## **SKCO SUBDIVISION, RESUBDIVISION OF**

APPLICATION NUMBER 7 DATE February 5, 2015

REQUEST Subdivision

# DETAIL SITE PLAN

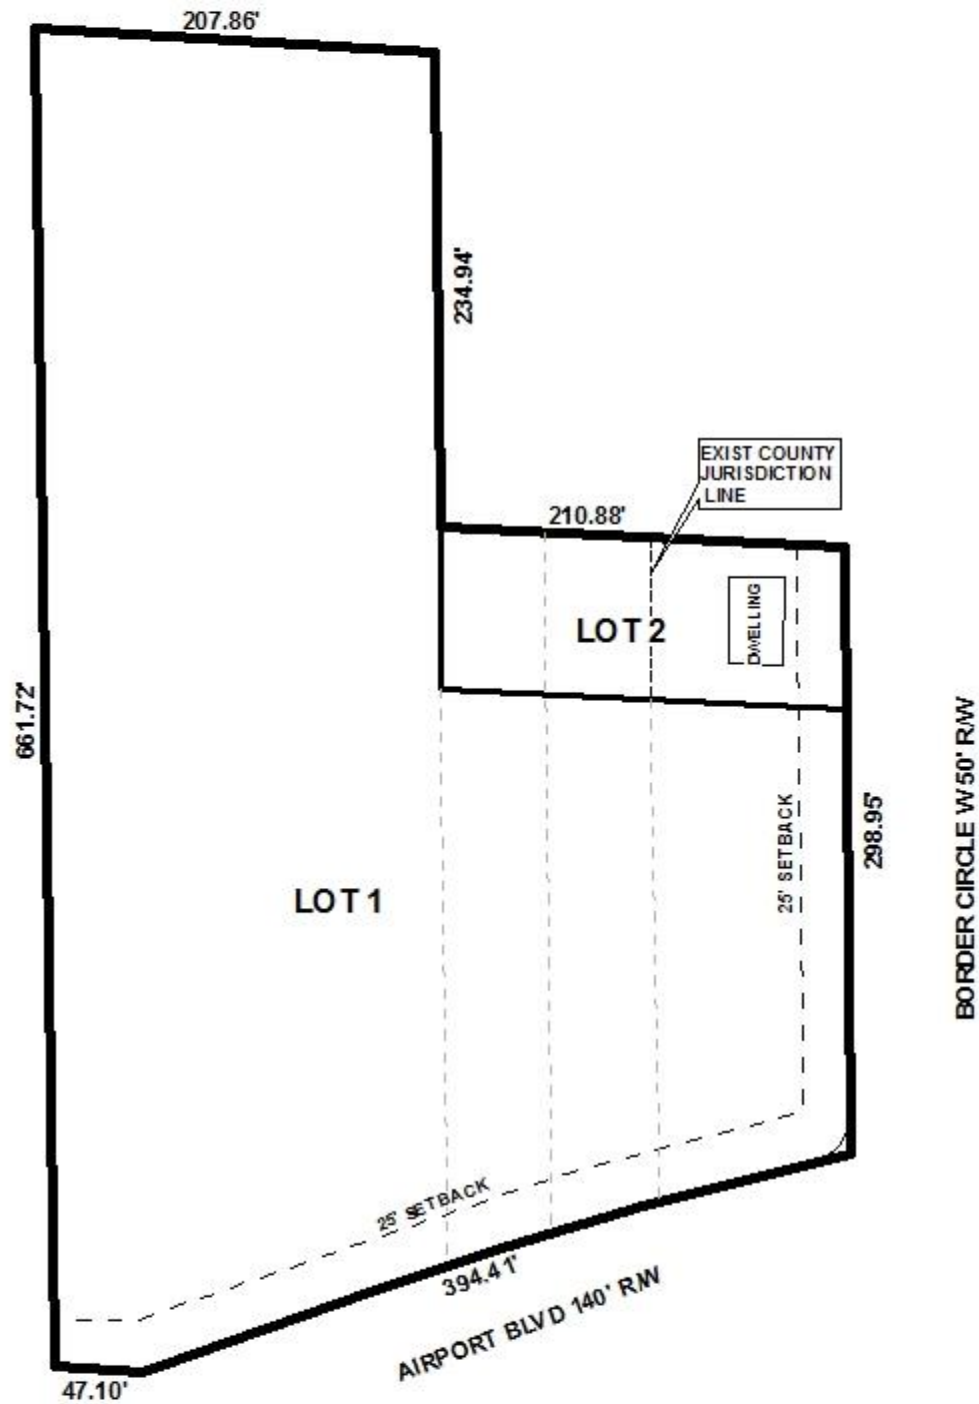
The site fronts both Airport Boulevard and Border Circle West, with 140' and 50' rights-of-way respectively, compliant with Section V.B.14. of the Subdivision Regulations. Therefore, no right-of-way dedication is required along most of the frontages. However, as indicated on the plat, a corner radius of 25' should be dedicated at the Northwest corner of Airport Boulevard and Border Circle West.

The site has street frontage of 394'± on Airport Boulevard and 298'± on Border Circle West. As a means of access management, Lot 1 should be limited to two curb cuts to Airport Boulevard and one curb cut to Border Circle West, with size, location, and design to be approved by Traffic Engineering. Lot 2 should be limited to its existing curb cut to Border Circle West, with size, location and design to be approved by Mobile County Engineering.

As on the plat, the lot sizes in both square feet and acres should be retained on the Final Plat, adjusted for any required dedication, or a table should be furnished on the Final Plat providing the same information. And as on the plat, the 25' minimum building setback line should be retained on the Final Plat along all street frontages.

A note should be required on the Final Plat stating that a buffer, in compliance with Section V.A.8. of the Subdivision Regulations, shall be provided along all portions of Lot 1 bordering on residential properties within the County. A note should also be required on the Final Plat stating that if Lot 2 is developed commercially, a buffer, in compliance with Section V.A.8. of the Subdivision Regulations, must be provided where that lot adjoins residential property.

- 1) de-annexation of the rear portion of Lot 2 from the City of Mobile into the County prior to signing the Final Plat;
- 2) dedication of a 25' corner radius at the Northwest corner of Airport Boulevard and Border Circle West;

- 3) placement of a note on the Final Plat stating that Lot 1 is limited to two curb cuts to Airport Boulevard and one curb cut to Border Circle West, and Lot 2 is limited to one curb cut to Border Circle West, with the size, location and design to be approved by Traffic Engineering;

- 4) retention of the labeling of the lot sizes in both square feet and acres, adjusted for any required dedication, or the furnishing of a table on the Final Plat providing the same information;

- 5) retention of the 25' minimum building setback line along all street frontages on the Final Plat;
- 6) placement of a note on the Final Plat stating that a buffer, in compliance with Section V.A.8. of the Subdivision Regulations, shall be provided along all portions of Lot 1 bordering on residential properties within the County;

- 7) placement of a note on the Final Plat stating that if Lot 2 is developed commercially, a buffer, in compliance with Section V.A.8. of the Subdivision Regulations, shall be provided where the lot borders residential properties;
